September 18, 2020

RE: Response to ADEC Review Comments & Work Plan Requirements on the 2019 Annual Site Status Report ADEC Hazard ID: 313 Chevron USA Refinery-Nikiski

FIGURE 1			
	SOUTH END ROCK REVETMENT			
D	CROSS-SECTION			
)	CHEVRON ENVIRONMENTAL MANAGEMENT COMPANY FORMER KENAI REFINERY			
729	NIKISKI, ALASKA			
ed By: BF		Scale: AS SHOWN	Date: 9/15/2020	File: 154-CROSSSECTION-202009

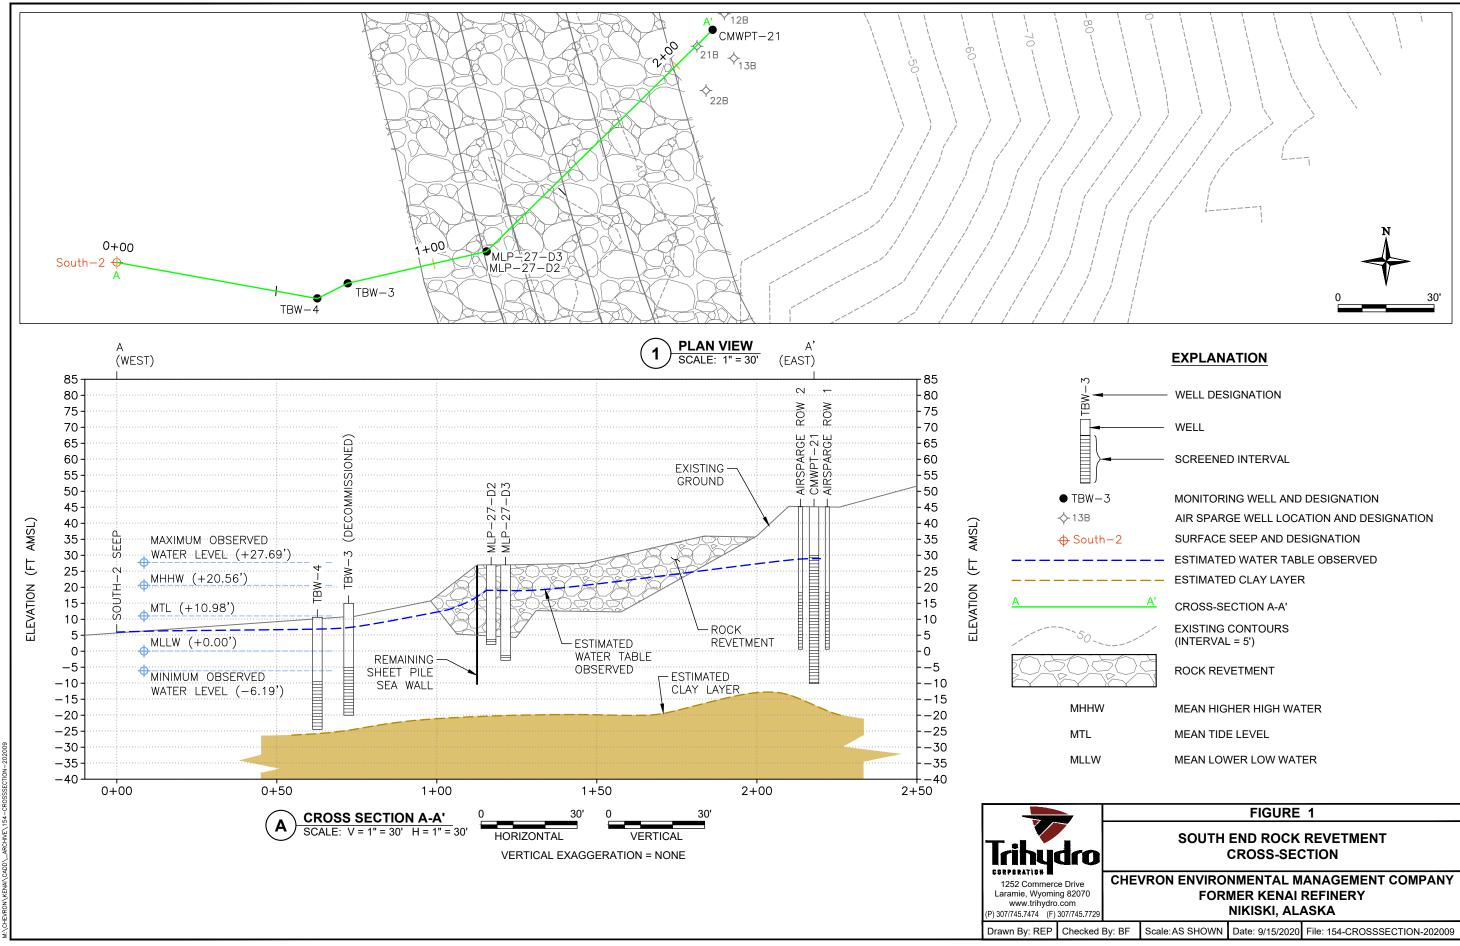
<u>ADEC Comment</u>: In order to understand the flow dynamics of the beach zone, ADEC request that cross sections and groundwater contour maps present the subsurface portion of the sea wall. The cross section should show the top and bottom elevation of the sea wall as well as the air sparge wells, temporary beach wells and beach tide elevations. Groundwater contour maps and top of clay map should show the extent of the subsurface sea wall as an aid in understanding the dynamics of subsurface flow.

<u>ADEC Comment</u>: The beach seeps may not represent the full extent of hydrocarbon impacts crossing the high tide line to the ocean as demonstrated by the temporary beach monitoring well results from wells installed in 2018. Chevron will install a monitoring well to verify the air sparge system is treating beach groundwater concentrations at depth and that the beach is not being impacted.

Chevron has proposed installing only one temporary beach monitoring well this year rather than the three previously discussed. ADEC agrees to this plan at the approximate location of well TBW-03. If contamination is discovered at this location, additional wells will be required to determine the extent.

Chevron Response: Chevron created Figure 1, South End Rock Revetment Cross-Section, to better demonstrate the flow dynamics of the beach zone. The cross-section includes sea wall elevations, the projected clay layer elevation, approximate groundwater elevations, beach tide elevations, air sparge wells, monitoring wells, temporary beach wells, and beach seep locations within this vicinity.

Chevron will display the extent of the subsurface sea wall on the 2020 Groundwater Surface Elevation Figure and the Topography of Lower Clay Aquitard Figure, included in the 2020 Annual Site Status Report.

Chevron Response: Chevron installed one temporary monitoring well, TBW-4, on July 21, 2020. The monitoring well was installed downgradient and to the west of the previous TBW-3 location. The well location is presented on Figure 1, South End Rock Revetment Cross-Section. This location was sampled in August 2020 and will be sampled tri-annually or until damaged by the ocean. If contamination is discovered at TBW-4, additional wells may be installed to determine the extent of contamination.
